**Reference:** New Proposed Statewide Draft Construction General Permit

**Subject:** Comment Letter – Draft Construction Permit

CASQA offers the attached summary and detailed comments and observations on the March 2008 draft permit in Attachment 1 to this letter. The comment and observations address the practical implementation, policy implications, requests for clarification of requirements, and suggested language for improving the draft permit. The comments and observations in Attachment 1 are generally structured by identifying the subject issue, with a summary comment, followed by detailed comments. In this latter section, alternative language or details on an issue are identified. Two additional attachments provide further details on numeric effluent limits (Attachment 2) and a technical review of use of RUSLE and MUSLE in various parts of the draft permit (Attachment 3).

Figure 1. Local erosion and deposition at a construction site

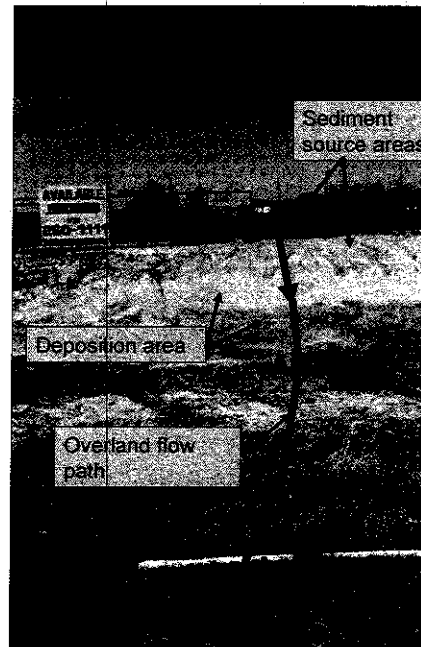
- a. The intent of this worksheet is not clear. Is it a worksheet that estimates the likelihood that whatever sediment, regardless of amount, that is eroded on-site will be transported to a receiving water body? Apparently the worksheet can be used to determine whether erosion control is needed. What is the tool that helps the planner determine the erosion control that will be installed? Is the worksheet essentially giving a sediment delivery ratio that will be used in conjunction with a sediment production computation to estimate sediment delivery in terms of an absolute amount to the water body? Or, is the worksheet estimating sediment delivery by computing sediment delivery amount. The idea of risk is not clear.

- Why not compute an expected sediment delivery amount and then apply erosion and sediment control to control sediment delivery to an allowable level?
- b. The proximity to receiving water topic needs additional consideration. If the source area is directly connected to the receiving water body, a value of 50 is assigned regardless of the amount of sediment produced. A better approach would be to compute a sediment production value and use the proximity to stream index as a sediment delivery ratio multiplier. Also, increased detail of the intervening area between the source area and the direct connecting path and sediment transport characteristics along the sediment transport path is needed. Consider Figures 1 and 2 below. These photographs are of a construction site after placement of fill and grading. Note that overland flow runoff flows along a relatively long, flat area, then across a short steep area, then on to a flat area that is well covered with grass, and then into a channel that carries storm runoff into a perennial stream about a  $\frac{1}{4}$  mile away. Note the high amount of deposition that is caused by the low steepness that is grass covered between the erosion area and the channel that collects the overland land flow. As much as 80 percent of the sediment that was eroded on this site never left the site because of this deposition. The permit procedure should take into account the likelihood of deposition between the erosional areas and the point that the sediment leaves the site. A multiplier involving perhaps four classes is more appropriate than the additive factor of either 0 or 50.

Figure 2. Local erosion and deposition and delivery to a ditch that drains to an offsite water body.

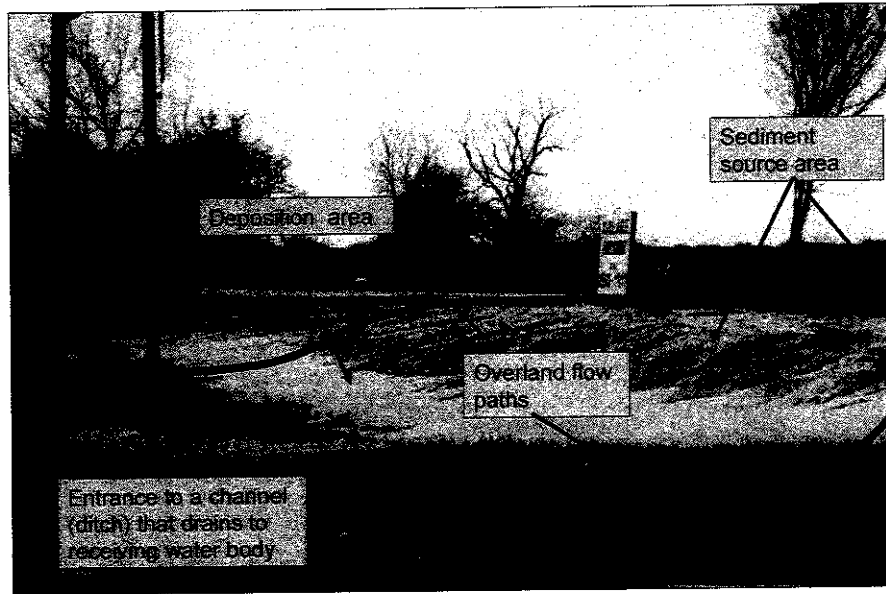
- c. The question "Will the site be cleared and graded outside of the designated rainy seasons and will Erosivity Index R be less than 5?" is unclear? Must both of these

conditions be met for a 0 score. If R is less than 5, does the time of clearing and grading make a difference in assigning an index value? Why not ask the question in terms of the R value for the period that the site is susceptible to erosion. If the R for this period is less than 5, then assign a value of 0. Otherwise assign a multiplier value related to the factor of the total annual R during which the site is susceptible to erosion.
